Access Compliance Report

Public Rights-of-Way

(Curb Ramps)

Intersection ID: 11185	Main Street: ALLEGHANY_ST	Cross Street: CARROWMORE_PL	Location: SE
ADA ID: AF87E56A82F9	Ramp Type: Perp	Initial Pass/Fail: Fail	Overall Compliance: No
Severity Score: 26.25			
Codes/Mitigation Info/Possible Solution		Field Measurements/Component Compliance

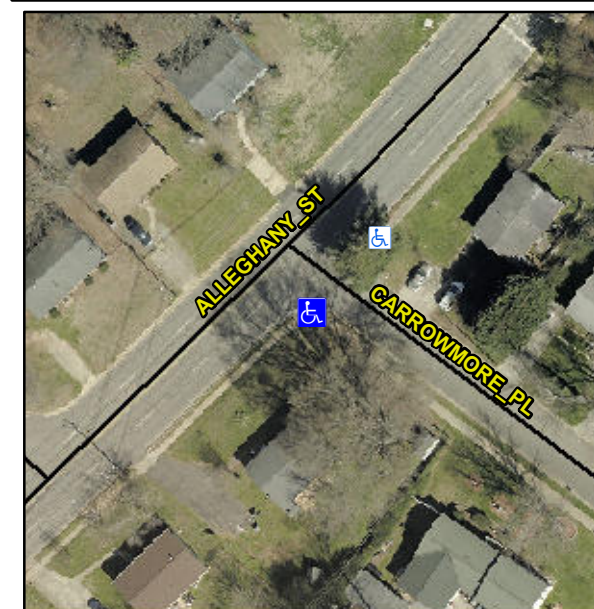
Not Found, R304.2.2, R304.5.3

Compliance	Description	Data	Compliance	Description	Data
N/A	Ramp Length (in)	24.0	No	Ramp Slope (%)	13.3
Yes	Ramp Width (in)	48.0	No	Ramp XSlope (%)	3.7
N/A	Flare Type LT	N/A	N/A	Flare Type RT	N/A
N/A	Flare Slope LT (%)	N/A	N/A	Flare Slope RT (%)	N/A
N/A	Flare Traversable LT?	N/A	N/A	Flare Traversable RT?	N/A
N/A	Landing Length (in)	N/A	N/A	DWS Provided?	N/A
N/A	Landing Width (in)	N/A	N/A	DWS Contrast?	N/A
N/A	Landing Slope (%)	N/A	N/A	DWS Length (in)	N/A
N/A	Landing X Slope (%)	N/A	N/A	DWS Full Width?	N/A
N/A	Landing Curb? (Y/N)	N/A	N/A	DWS Offset (in)	N/A
N/A	Shared Landing?	N/A			
N/A	Gutter Ponding?	N/A	N/A	Gutter Slope (%)	N/A
N/A	Gutter Lip Ht (in)	N/A	N/A	Gutter X Slope (%)	N/A
N/A	Painted X Walk1?	No	N/A	Painted X Walk2?	N/A
	X Walk 1 Direction	To NE		X Walk 2 Direction	N/A
N/A	X Walk 1 Width (in)	N/A	N/A	X Walk 2 Width (in)	N/A
	X Walk 1 Slope (%)	2.8		X Walk 2 Slope (%)	N/A
	X Walk 1 X Slope (%)	1.9		X Walk 2 X Slope (%)	N/A

Remove & Replace Entire Ramp.
